STAFF DESIGN COMMISSION REPORT RE-REVIEW

Project Name: Kensington School
Project Address: 840 E. Kensington Road
Prepared By: Steve Hautzinger

DC Number: 16-031
Petitioner Name: Charles Marlas
Petitioner Address: Kensington School
743 McClintock Drive
Burr Ridge, IL 60527
Original Meeting Date: April 26, 2016
Re-Review Meeting Date: August 9, 2016

1. Approval of the proposed architectural design for a new preschool / children's day care center.

EXHIBIT A – Approved PUD Site Plan and Landscaped Plaza

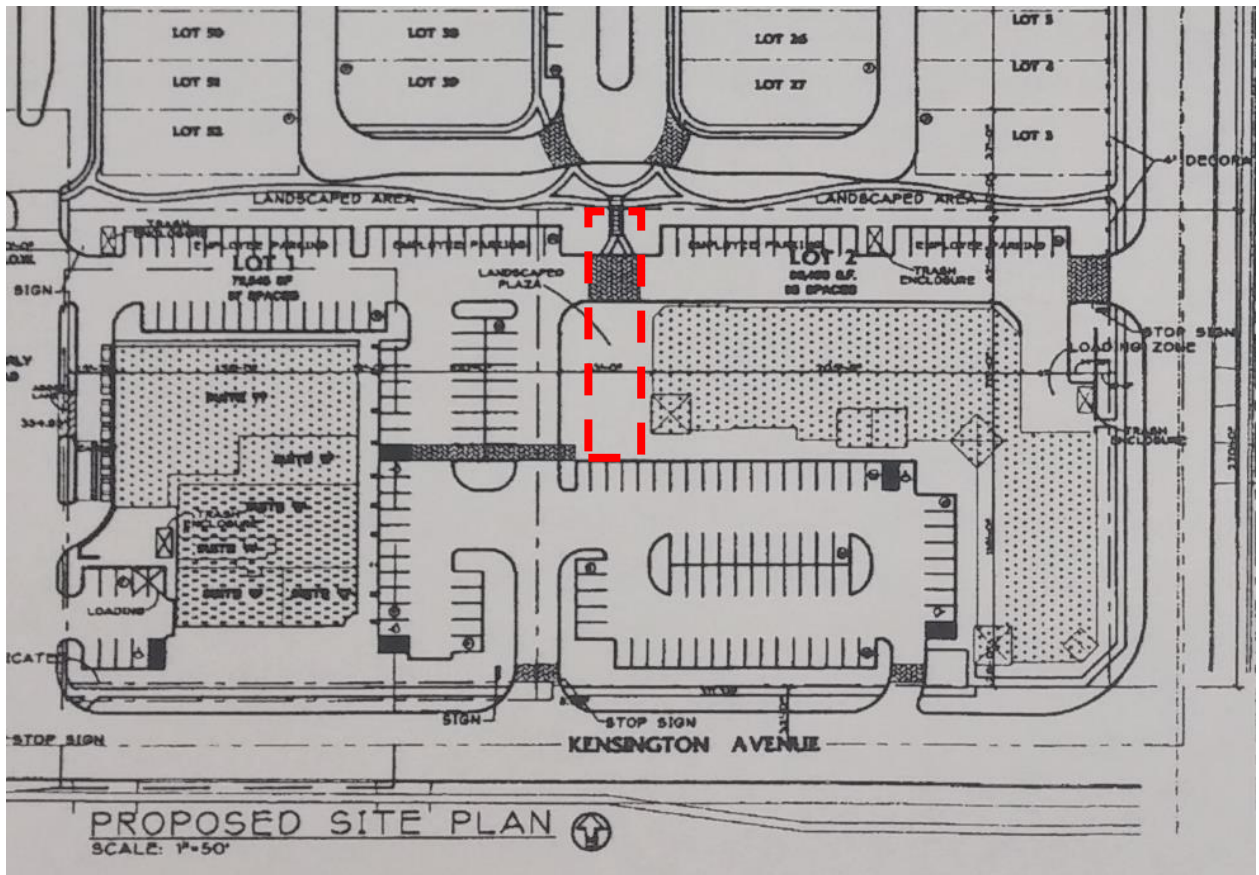
Landscaped Plaza. The original PUD approval included a landscaped pedestrian plaza at the northwest corner of the site to connect the commercial properties to the residential neighborhood to the north. To accommodate this plaza, the Plat of Subdivision includes a 25 foot wide pedestrian access easement which is setback 31 feet from the west property line, and runs 144 feet north to south from the north property line (refer to Exhibit A). This feature is a significant component of the overall master plan for the Arlington Market development, and it was recommended that the Kensington School site design be revised to include it.

Landscaped Plaza. The Petitioner was encouraged to study enhancing the pedestrian link. It was suggested to chamfer the northwest corner of the fence and consider limiting the depth of the plaza.

Landscaped Plaza. The building and parking has been shifted to the east to accommodate a continuous 20-foot wide pedestrian plaza along the west end of the site, versus 25 foot wide per the existing PUD and easement. The plaza includes a 6-foot wide concrete walkway with landscaping on both sides.

Landscaped Plaza. The proposed 20-foot wide pedestrian plaza accomplishes some of the spirit of the original PUD approval, providing a pleasant pedestrian connection through the site connecting the commercial properties to the south with the residential neighborhoods to the north.
